Report Type: DA Access Report
Reference Number: 20192
Client: Land and Housing Corporation
Site Address: Rosemeadow Stage 3,
Lot 194 Road No. 02, Rosemeadow, NSW

ACCESS REPORT

This Access Compliance Report is to accompany a Development Application for a SEPP Seniors and People with a disability development proposed at Rosemeadow Stage 3 - Lot 194 Road No. 02, Rosemeadow, NSW

Ground floor plan

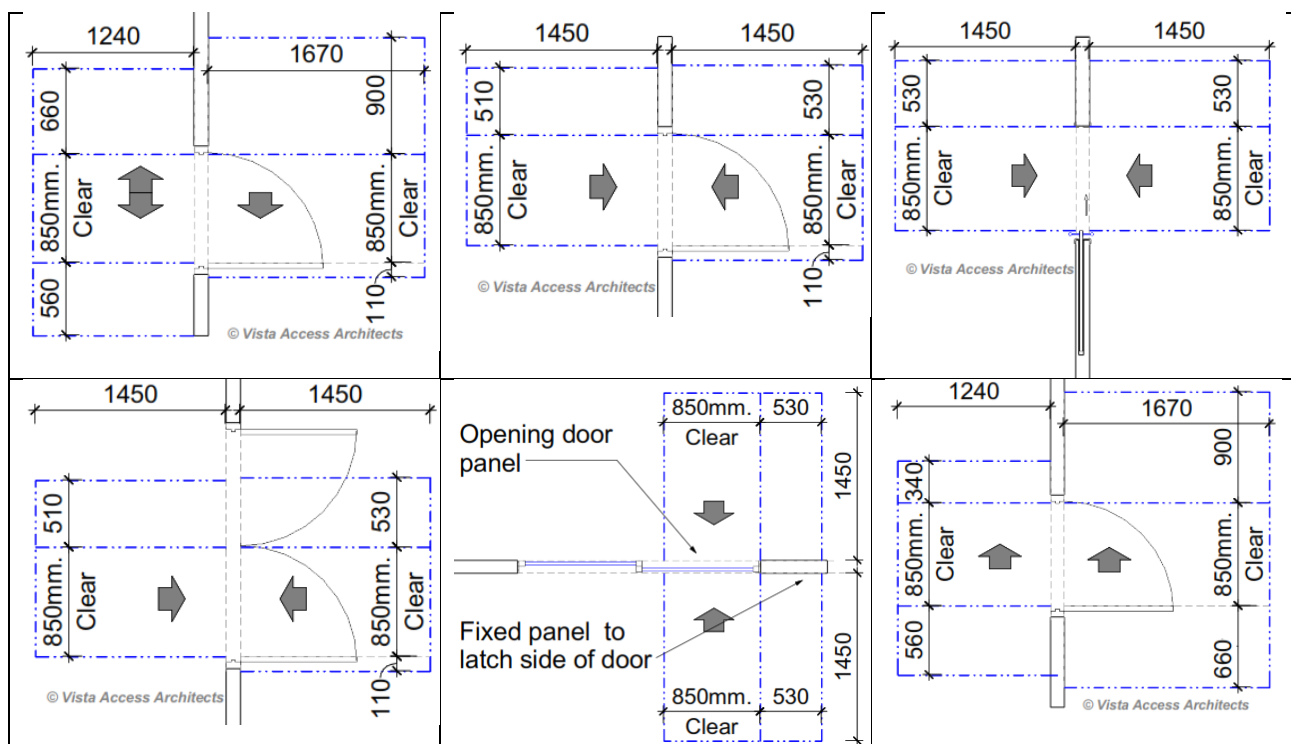
BCA Part D3 Access for People with a Disability
	BCA D3.1 General building Access requirements SOU refers to a Sole Occupancy Unit
Requirement	Class 2 - building containing more than 2 SOUs i.e. sole-occupancy units For residential use components, access is required: <ul style="list-style-type: none"> - From a required accessible pedestrian entrance to at least 1 floor with SOUs and till the entry of door of each SOU on that level. - To and within 1 of each type of room or space in common use. - Where floor is accessed by an AS1428.1 ramp or lift, access is required to the entry doorway of each SOU on that level and to and within all common use areas on that level.
Compliance Comments	Complies. <ul style="list-style-type: none"> - Access has been provided from the main pedestrian entry doorway to the entry doors of all SOUs at least 1 level by means of accessible pathways and lifts. - Access has been provided to at least 1 of each common use space such as communal garden on Ground floor level. - Access has been provided to common use garbage storage rooms on Basement floor level. Details to be verified at CC stage of works.

Requirement	Class 7a - Covered car park. <ul style="list-style-type: none"> - To and within any level containing accessible carparking spaces.
Compliance Comments	Complies. Access has been provided to all Basement level containing Accessible carparking spaces. Details to be verified at CC stage of works.
	BCA Part D3.2 Access to buildings
Requirement	Accessway is required from; <ul style="list-style-type: none"> - Main pedestrian entry at the site boundary for new buildings. - Any other accessible building connected by a pedestrian link. - Accessible car parking spaces.
Compliance Comments	Complies. <ul style="list-style-type: none"> - Level Access has been provided from the main pedestrian entry at the site boundary for Building C. - Access by means of 1:20 grade walkways has been provided from the main pedestrian entry at the site boundary for Building A & B. Note- Details of all 1:14 ramps and 1:20 walkways to be verified at CC stage. Ensure continuous handrails with handrail extensions are provided on both sides of all 1:14 ramps and all 1:20 walkways have max. length of no more than 15M between midlandings. <ul style="list-style-type: none"> - Access has been provided from accessible car parking spaces by means of lifts. Details to be verified at CC stage of works.

Appendix A- Pathway to Bus stop assessment

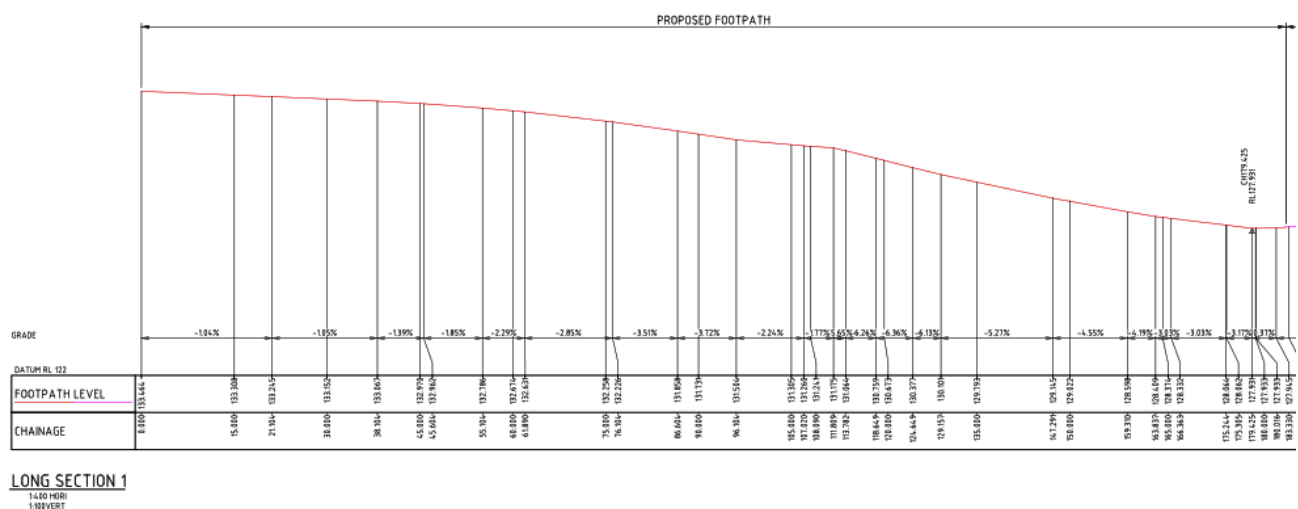
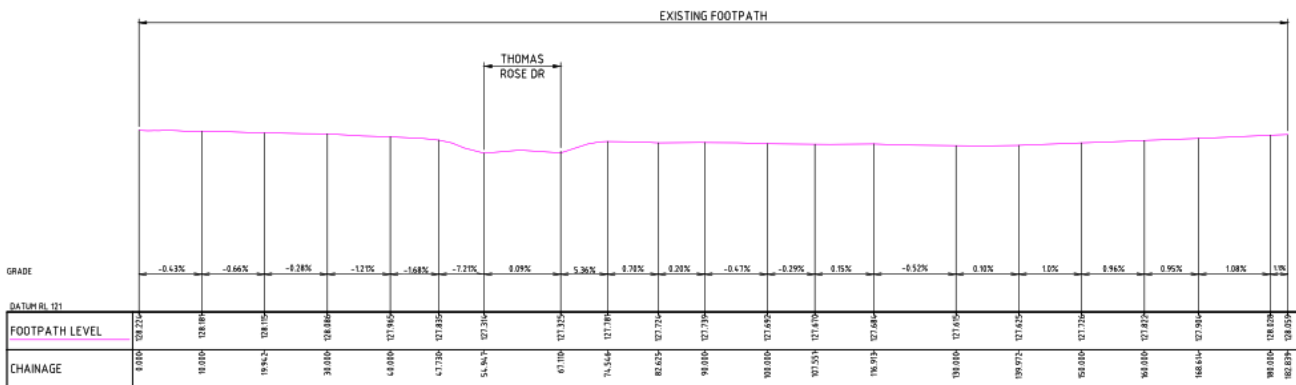
Pathways to Bus stop nominated by town planner
Requirement	Clause 26 Bus stop to be at a distance of not more than 400 M from the site of the proposed development and the distance is accessible by means of a suitable access pathway.
Compliance Comments	Complies The distance to the bus stops from the subject site is less than 400M Details to be verified at CC stage of works.
Requirement	Clause 38 Accessibility The proposed development should: (a) have obvious and safe pedestrian links from the site that provide access to public transport services or local facilities, and (b) provide attractive, yet safe, environments for pedestrians and motorists with convenient access and parking for residents and visitors.
Compliance Comments	Complies Pedestrian links from the subject site to the nominated bus stops have been provided via kerb ramps at dedicated crossings. Note that the nomination of the bus stops is by others. Details to be verified at CC stage of works.

Requirement	Clause 26 Overall average gradient along a pathway from the site of the proposed development to the public transport services (and from the transport services to the facilities and services referred to in subclause (1)) is to be no more than 1:14, although the following gradients along the pathway are also acceptable: (i) a gradient of no more than 1:12 for slopes for a maximum of 15 metres at a time, (ii) a gradient of no more than 1:10 for a maximum length of 5 metres at a time, (iii) a gradient of no more than 1:8 for distances of no more than 1.5 metres at a time.
Compliance Comments	Complies subject to minor rectification works involving a kerb ramp on Copperfield Drive. A detailed longitudinal grade survey has been provided that indicate grades (existing and proposed) of the pathways being within the range as required in Clause 26 of the SEPP HSPWD except for a kerb ramp on Copperfield Drive Details to be verified at CC stage of works.
